ADDENDUM NO. 1  
SEWER SYSTEM IMPROVEMENTS  
CONTRACT 19-01  
G.E. AND SANTA FE SEWAGE PUMPING STATION RENOVATIONS  
COLUMBIA, TENNESSEE  
WAUFORD PROJECT NO. 2000

Date of Addendum: Friday, May 31, 2019

**△ STANDARD MANHOLE FRAME & COVER**  
(SELF SEALING)

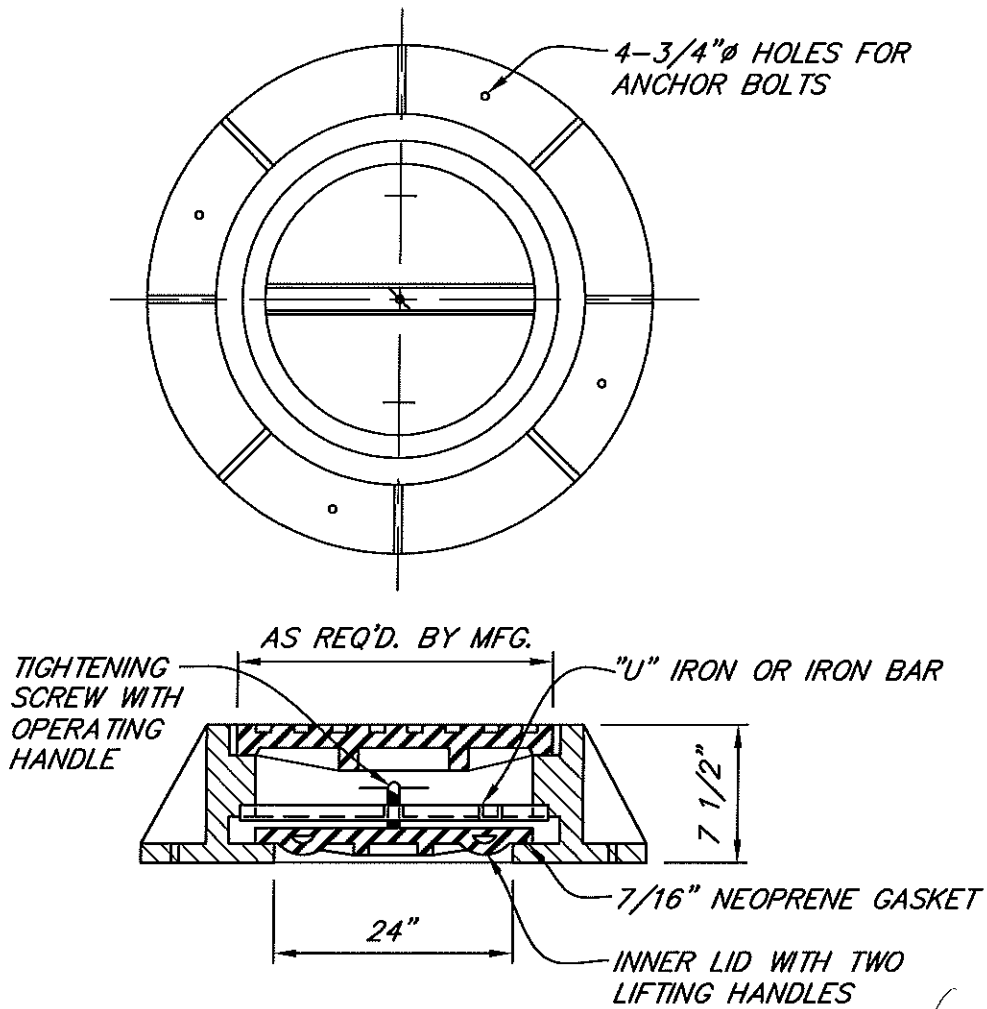
6. Plans, Sheet 1:

Add the manhole frame and cover details as depicted at the attached 8 ½” x 11” sheets.

APPROXIMATE WEIGHT OF FRAME AND COVER SHALL NOT BE LESS THAN 400 LBS. AS SPECIFIED.
